RE: CLEAN TEQ SUNRISE PROJECT MODIFICATION 4 – RESPONSES TO ADDITIONAL INFORMATION REQUESTS

CLEAN TEQ SUNRISE PROJECT

Clean TeQ Sunrise Project Modification 4 – Response to EA Groundwater Submissions

Figure 1

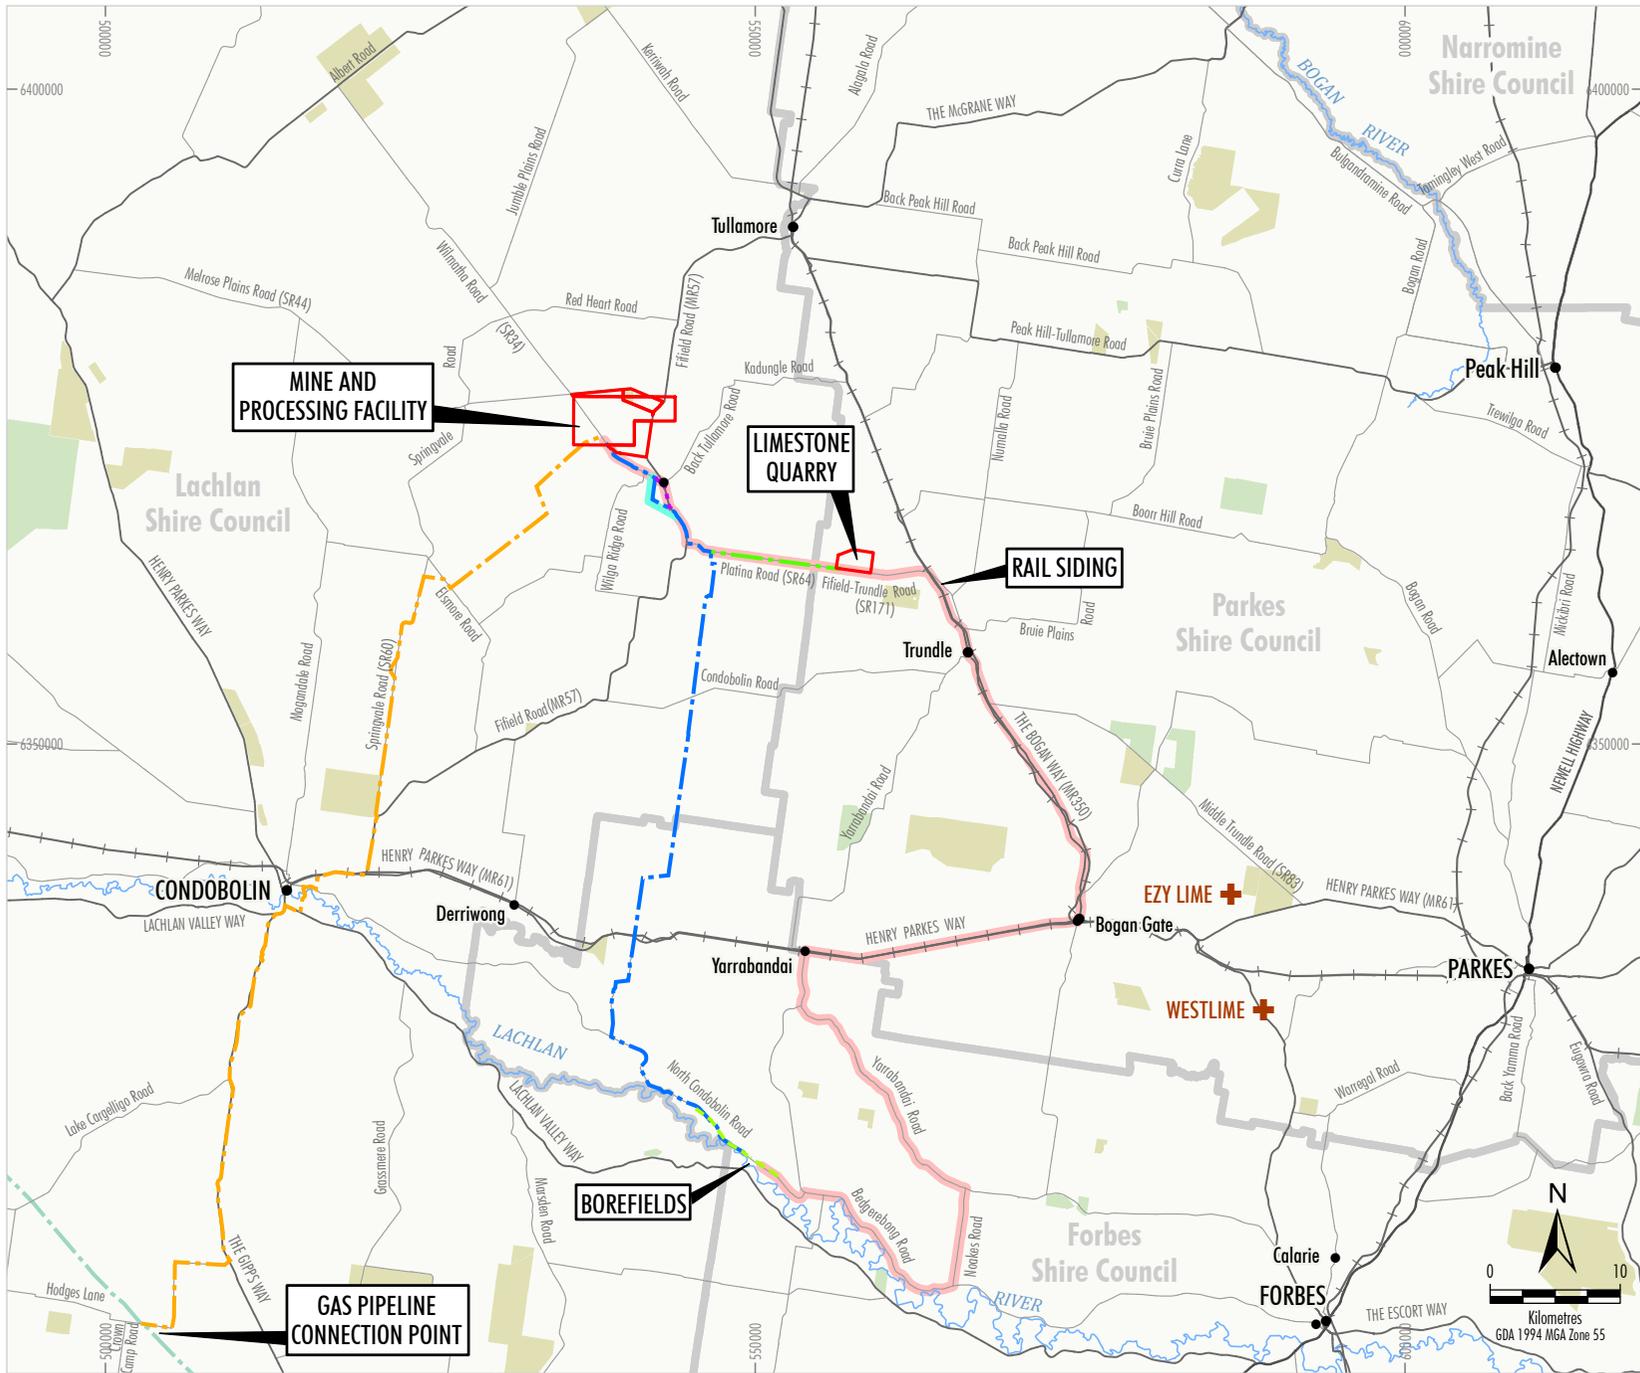
DP&E requested consideration of using rail to transport limestone from third party suppliers to the approved rail sliding.

There are a number of existing limestone quarries in the vicinity of Parkes, including the Ezy Lime and WestLime limestone quarries (Figure 1). The transport of limestone via rail from these two third party limestone suppliers to the Project rail siding would require:

1. development of rail spur(s) from the Orange Broken Hill Railway to third party limestone quarry operations to allow for direct loading of trains at the limestone quarry operations; or
2. development of a train load-out facility (including siding) along the Orange Broken Hill Railway to allow limestone transported by road from the limestone quarry operations to be loaded to trains.

The rail spur(s) required to link the third-party limestone quarries to the Orange Broken Hill Railway would be in the order of 3 to 6 km in length (depending on the route) and would have an estimated capital cost (including loading facility) of approximately \$9 million to \$12 million. The development of a train load-out facility is estimated to cost in the order of \$6 million.

Rail transport would also result in a significant increase in operating costs due to the additional limestone handling required. Rail transport direct from the third-party limestone quarries would require the loading and unloading of trains and the subsequent loading and unloading of trucks (i.e. double handling). If the limestone was transported by rail from a train load-out facility, limestone would need to be loaded and unloaded from trucks twice and from trains once (i.e. triple handling). Limestone transported by road would only need to be loaded and unloaded once.

Notwithstanding the above, the transport of limestone via rail from third party limestone suppliers to the Project rail siding may not even be logistically feasible as the utilisation of the rail network and Project rail siding by approved Project trains (e.g. sulphur deliveries) would not allow for regular shuttles between third party limestone quarries and the Project rail siding.

Figure 1 – Indicative modified mine and processing facility general arrangement

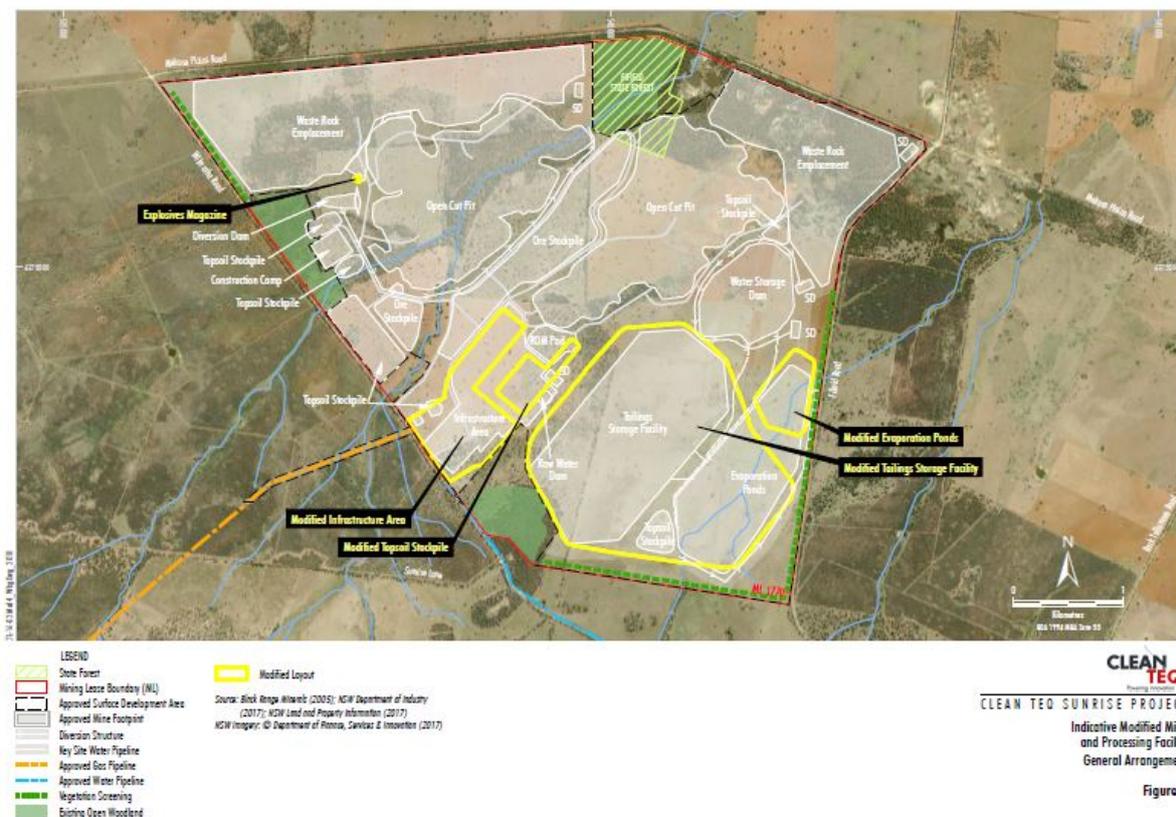
The NSW Department of Industry – Water (DI-Water) as part of its review of the Modification, requested an assessment of the potential seepage impacts associated with the modified TSF Tailings against the requirements of the NSW Aquifer Interference Policy (the AIP) (NSW Government, 2012). In particular, the DI-Water requested the following in its letter to the Department of Planning and Environment dated 16 March 2018:

- *Further assessment is requested to demonstrate whether there is a predicted change in the beneficial use category of the aquifer greater than 40 m from the activity, and if so whether it will prevent the long term viability of the dependent ecosystem or existing water supply works.*

The Modification includes an increase in capacity of the approved TSF to hold an anticipated increase in tailings volume (Figure 1). The TSF capacity would be increased by expanding the TSF footprint to approximately 380 hectares (ha) (Figure 1) and the final TSF elevation by approximately 4 metres. Other components of the tailings storage facility, such as tailings delivery, underdrainage, seepage collection and decant systems would be generally unchanged by the Modification.

Given the above, the modified TSF is not expected to lower the beneficial use category of the groundwater source beyond 40 m of the activity and therefore the relevant AIP minimal impact consideration would be met.
